### **TUALATIN ARCHITECTURAL REVIEW BOARD**

**April 9, 2014, 7:00 PM**

- A. Southwest Industrial Park Recommendation and Staff Report for AR-14-02

**L2.2**

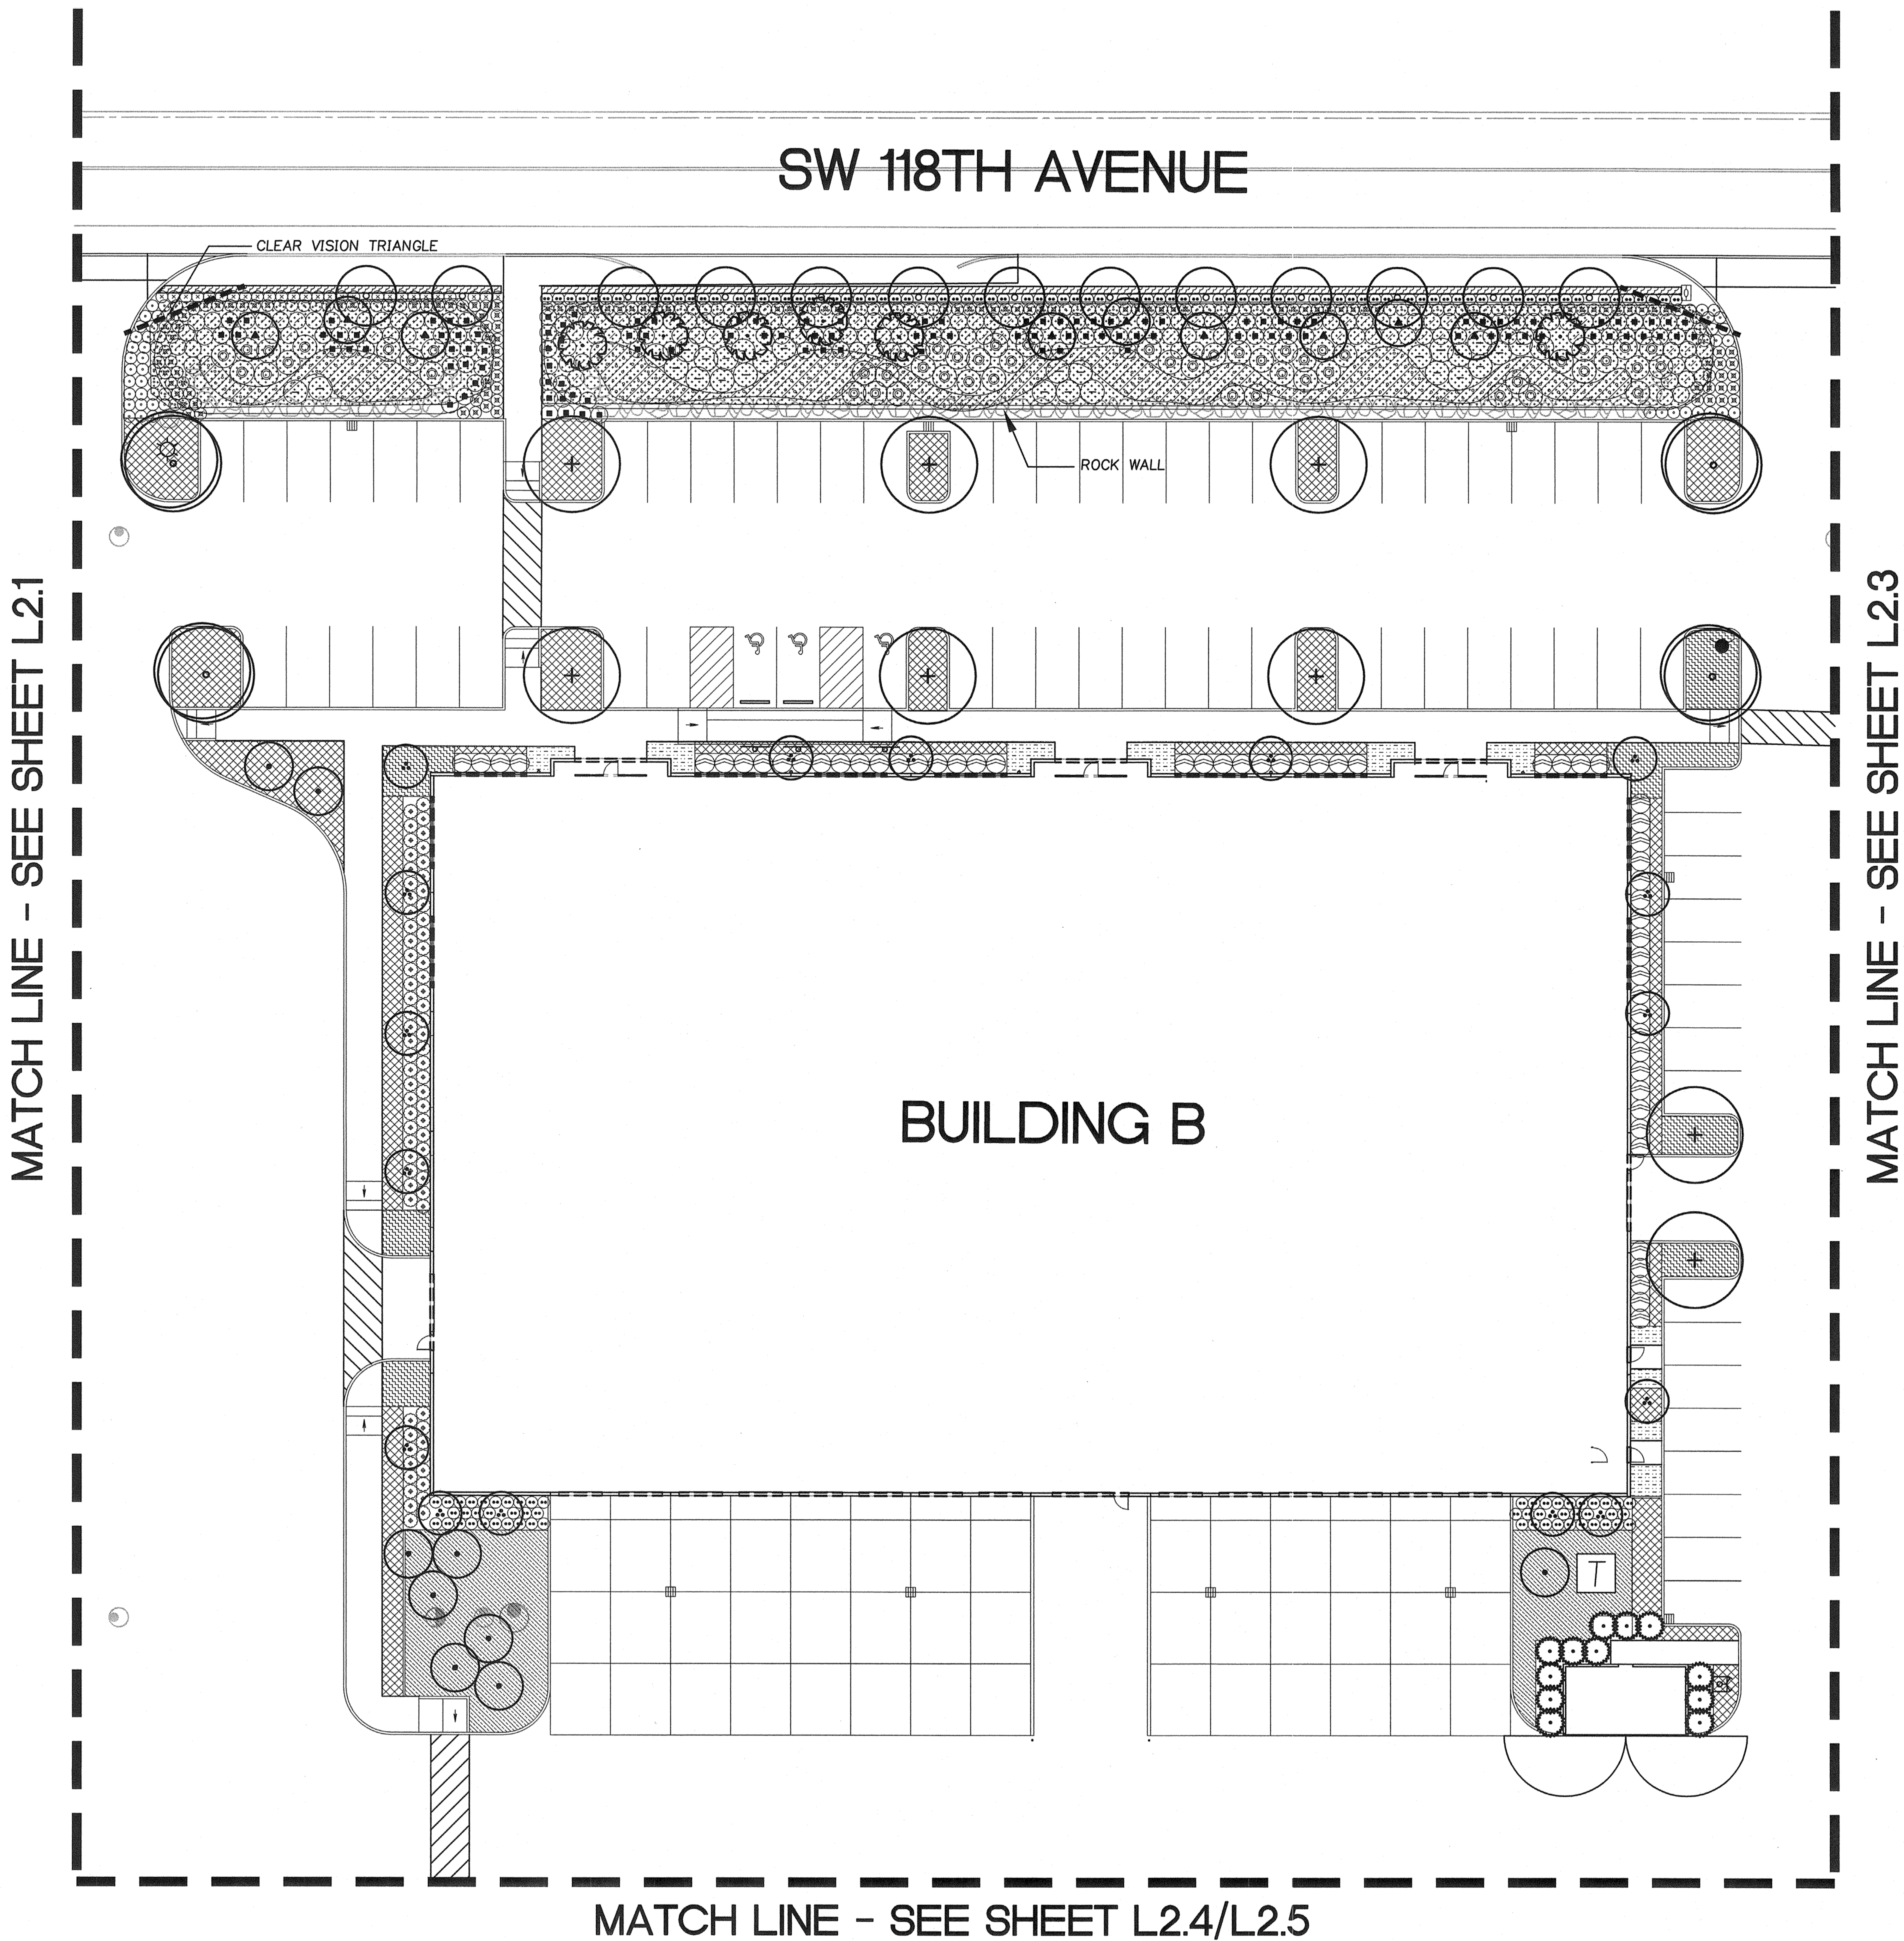
The landscape plans (Sheets L2.1-L2.5) illustrate the yards adjacent to SW 118<sup>th</sup> Avenue and SW Myslony Street planted to lawn or live groundcover and trees and shrubs.

Regarding (2), the planting plans (Sheets L2.1-L2.5) illustrate that all landscaped islands with trees are at least 5 ft wide inside of curb to inside of curb, with one exception. The island near the northeast corner of Building A and on the south side of the east landing of the accessway crossing illustrates a tree, but is less than 5 ft wide. The applicant needs to continue to propose a tree and widen the island to at least 5 ft inside of curb to inside of curb. Staff is aware that the site plan north and the utility north plan (Sheet C2.2A) illustrate a stormwater catch basin grate next to the island. Staff recommends a condition of approval to this effect.

The applicant can widen the majority of the island to accommodate the proposed tree, leaving the catch basin in place and open to stormwater flow from the south instead of both south and west. Additionally, it appears widening the island might not necessarily eliminate the adjacent parking space. The applicant can size the width of the space for compact parking, which Figure 73-1 permits to have a minimum stall width of 7.7 ft, allowing it to fit with an adjacent 5-ft island.

**1 NORTH ELEVATION**  
AA3.1 1/16"=1'-0"

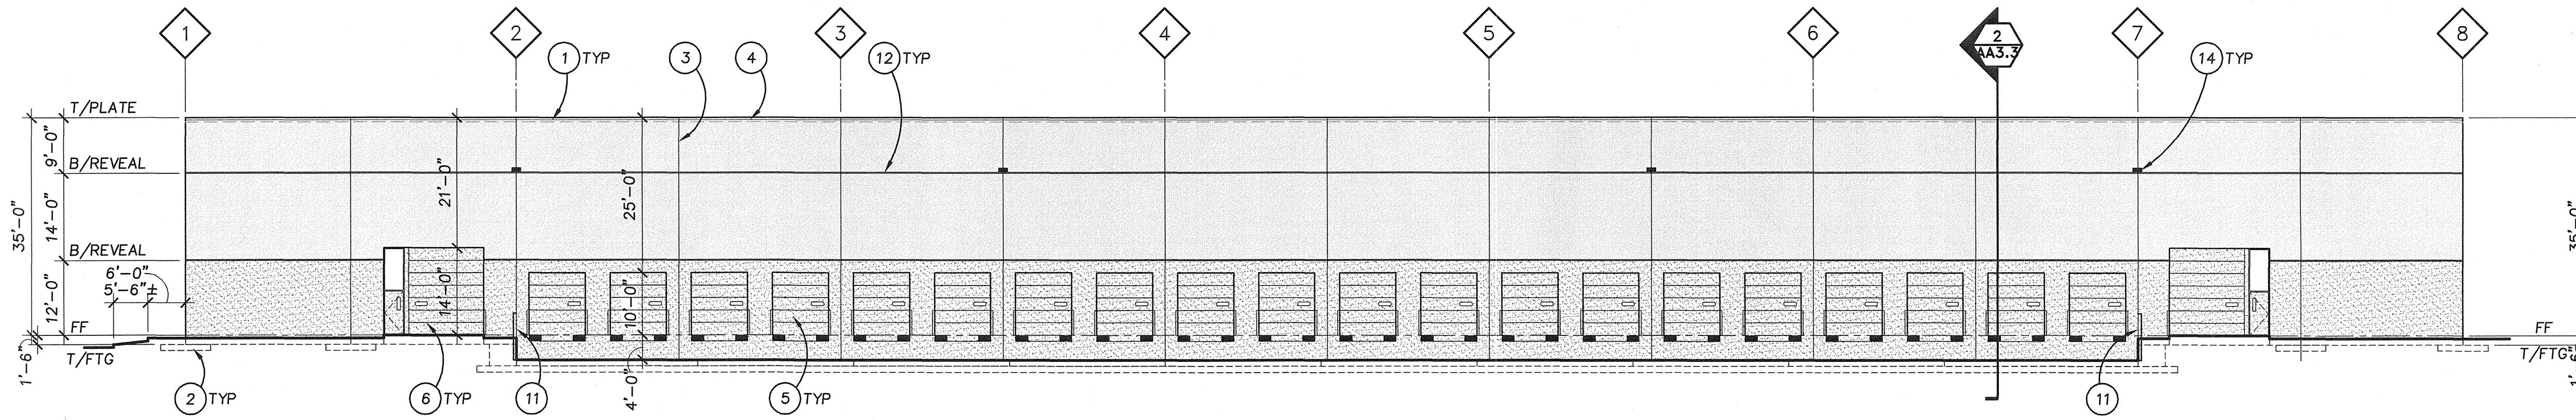
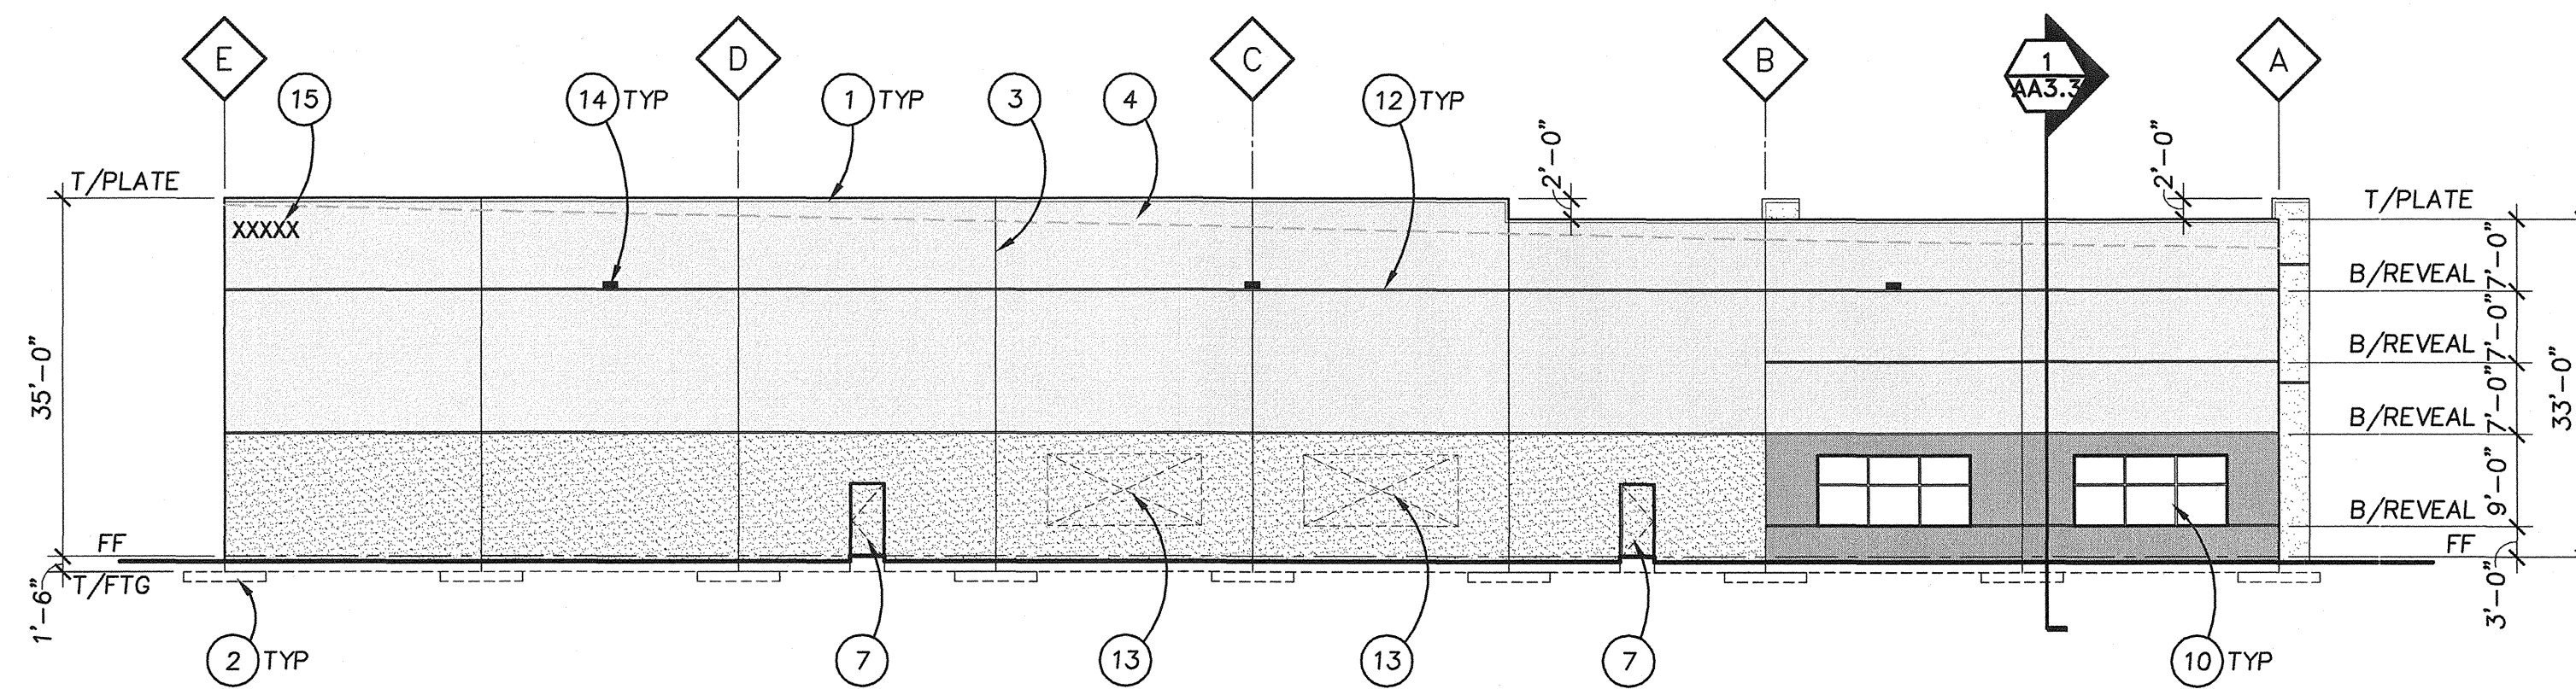
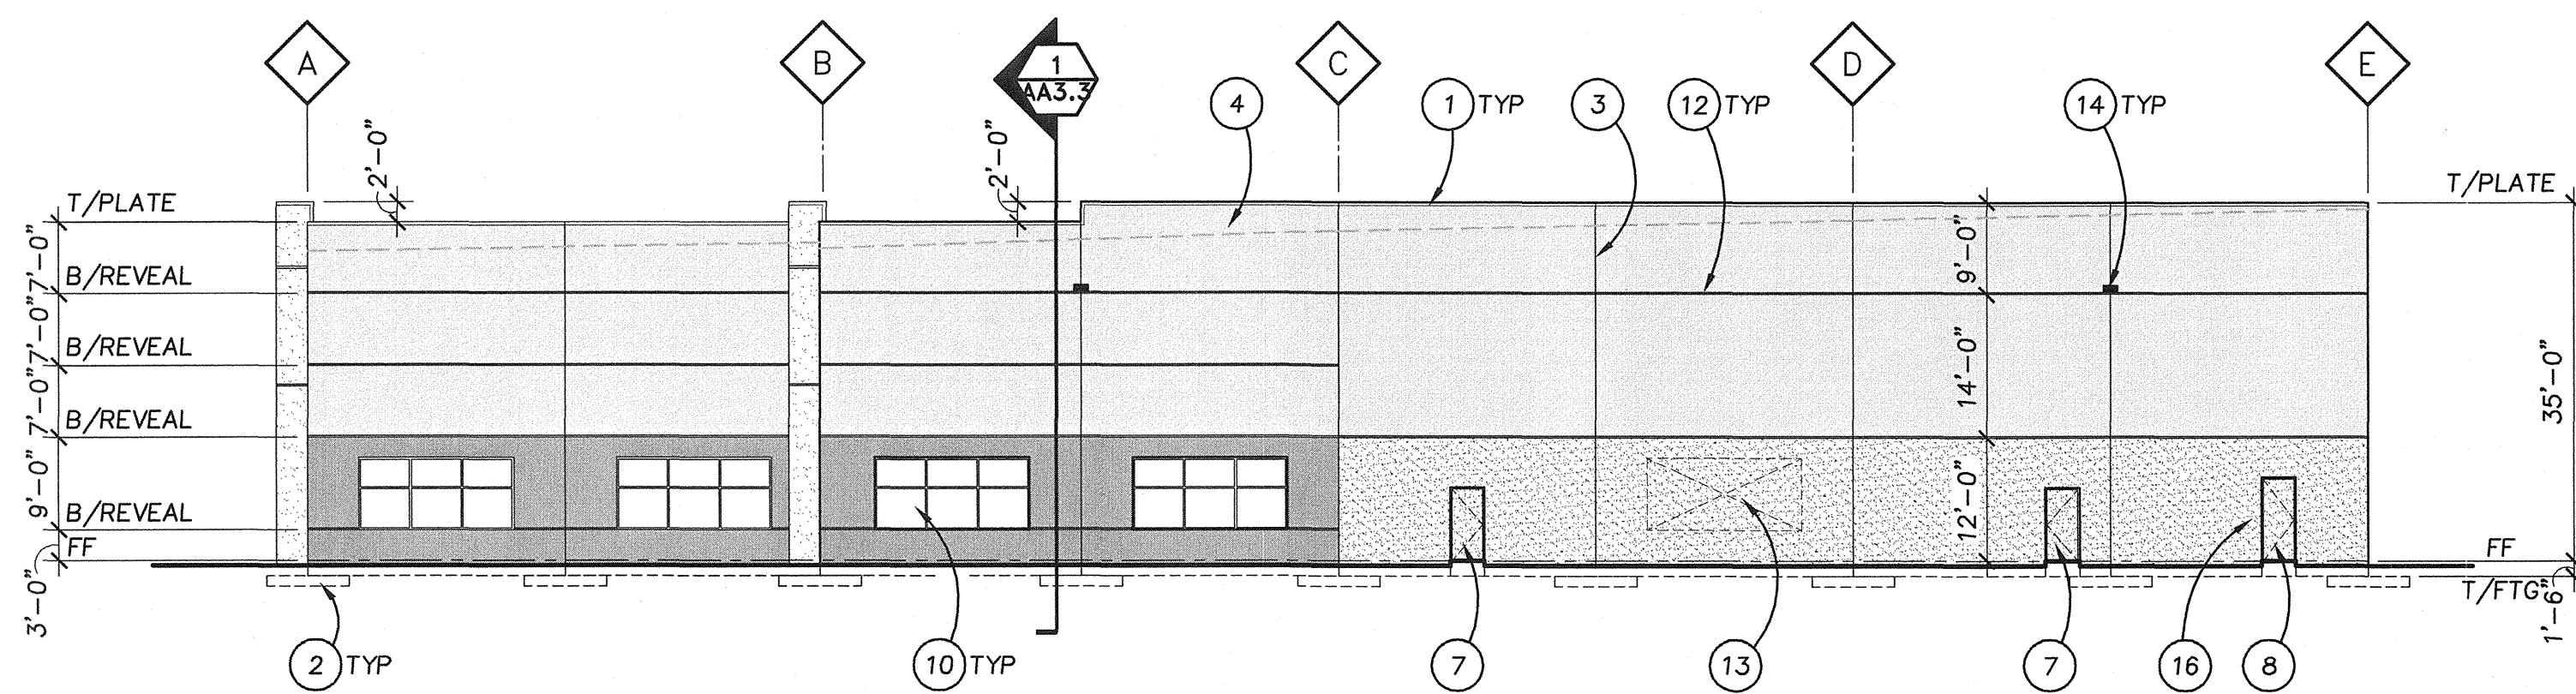
The building elevations (Sheets AA3.1, BA3.1, and CA3.1, Keynotes 14; and DA3.1, Keynote 17) note wall pack lights without providing some specification of the wall-mounted fixture(s). Though providing light, because the elevations proposed the wall-mounted fixtures at 26 ft above grade, tenants, employees, and pedestrians would see less well because of the likely glare and direct visibility of the bulbs from most areas near Buildings A-D, weakening the benefit of exterior lighting. To ensure compliance with this code section, staff recommends a condition that the applicant provide clarification about the wall-mounted fixtures and the angles of bulb visibility and revise the proposal if needed based on the *Guidelines for Good Exterior Lighting Plans* (Attachment 110), specifically information that relates to the “Acceptable” lighting fixtures and “Full-cutoff fixture” lighting angle diagrams in the guidelines on pages 2 and 4 respectively. Staff recommends a condition of approval to this effect.

For exterior wall-mounted lighting, the building elevations (Sheets AA3.1, BA3.1, and CA3.1, Keynotes 14; and DA3.1, Keynote 17) note wall pack lights without providing some specification of the wall-mounted fixture(s). As examined for the requirement of 73.160(3)(a), the wall pack lights are proposed at 26 ft above grade, a height that might make glare and direct bulb visibility intrude into the ROWs of SW 118<sup>th</sup> Avenue and SW Myslony Street. Because staff cannot determine compliance, the applicant needs to provide clarification about the wall-mounted fixtures and the angles of bulb visibility. Staff recommends a condition of approval to these effects for the requirement of (6).
